Appin Road Upgrade, Mount Gilead to Ambarvale

Submissions report

Roads and Maritime Services | March 2019

Prepared by WSP Australia Pty Ltd and Roads and Maritime Services
RMS.19.1192

Figure ES-1: Additional fauna fencing along western side of Appin Road at Noorumba Reserve

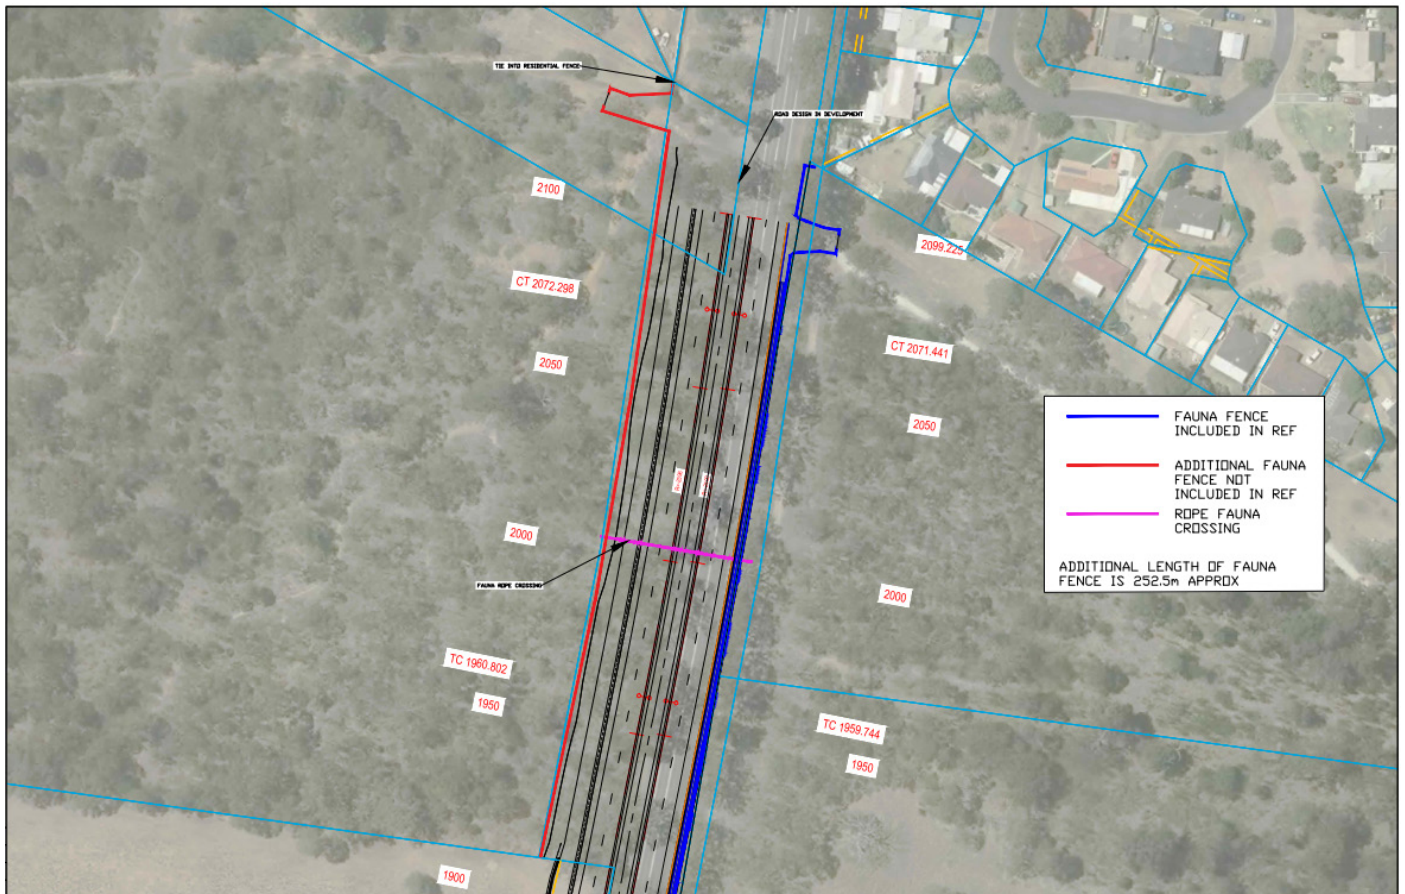
The REF proposal included the provision of a fauna fence and/or barriers at suitable locations on either side of Appin Road to prevent fauna accessing the road corridor. The proposed fauna fencing was predominantly focussed on the eastern side of Appin Road. However, the proposed change would result in the addition of about 252 metres of fauna fencing along the western side of Appin Road at Noorumba Reserve (refer to Figure ES-1).

The proposed change has been implemented based on the feedback and recommendations from OEH, independent expert reports and consideration of submissions raised by the community and key stakeholders.

As no additional vegetation clearing would be required beyond that proposed in the REF, the impacts of this change are consistent with those identified in the REF.

Figure 3-1: Proposed fauna fencing at Noorumba Reserve

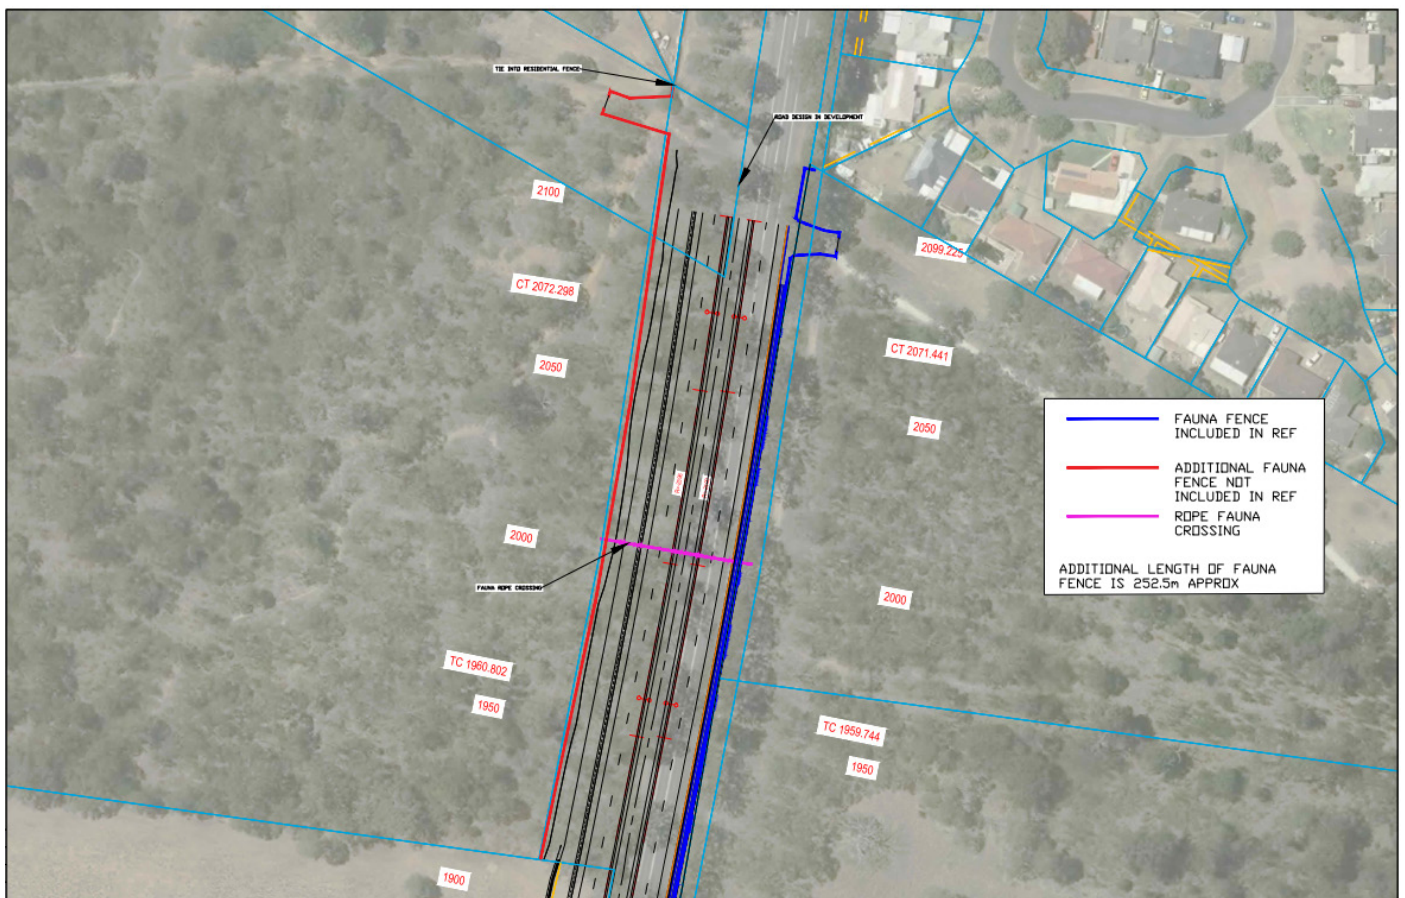
The REF proposal included the provision of a fauna fence and/or barriers at suitable locations on either side of Appin Road to prevent fauna accessing the road corridor. The proposed fauna fencing was predominantly focussed on the eastern side of Appin Road. However, the proposed change would result in the addition of about 252 m of fauna fencing along the western side of Appin Road at Noorumba Reserve (refer to Figure 3-1).

The proposed change has been implemented based on the feedback and recommendations from OEH, independent expert reports and consideration of submissions raised by the community and key stakeholders.

Similar to the proposed fencing in the REF, the fauna fence would typically comprise a 1.8 m chain wire fence with a galvanised sheet at the top to prevent climbing of fauna.

Figure 3-2 Typical cross-section of the fauna fence

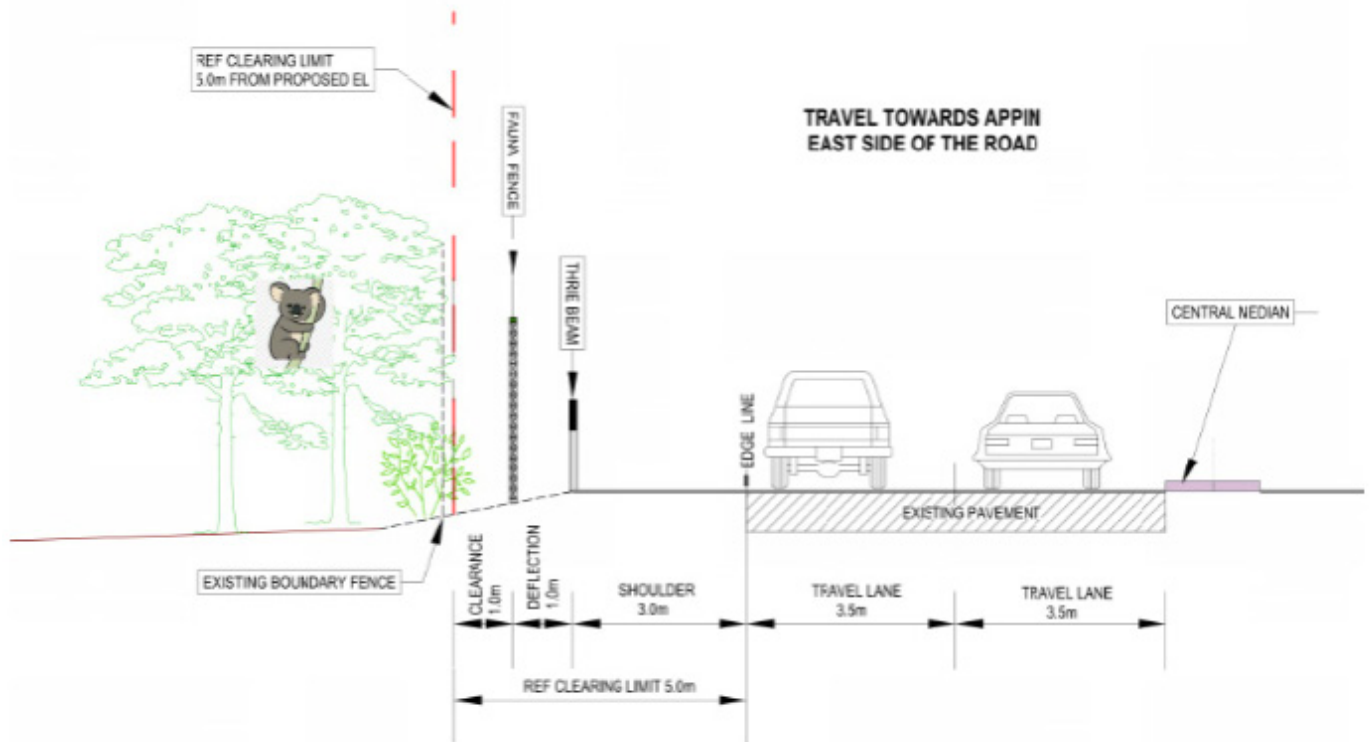
As identified in section 3.2 of the REF, clearing of up to five metres from the existing road pavement would be required for the installation of the fauna fence, safety barrier and to provide access for maintenance and repairs. A section of about 600 m in length would require a six metres cleared zone to accommodate installation of a culvert. The typical five metres cross-section for the fauna fence is shown in Figure 3-2 below.
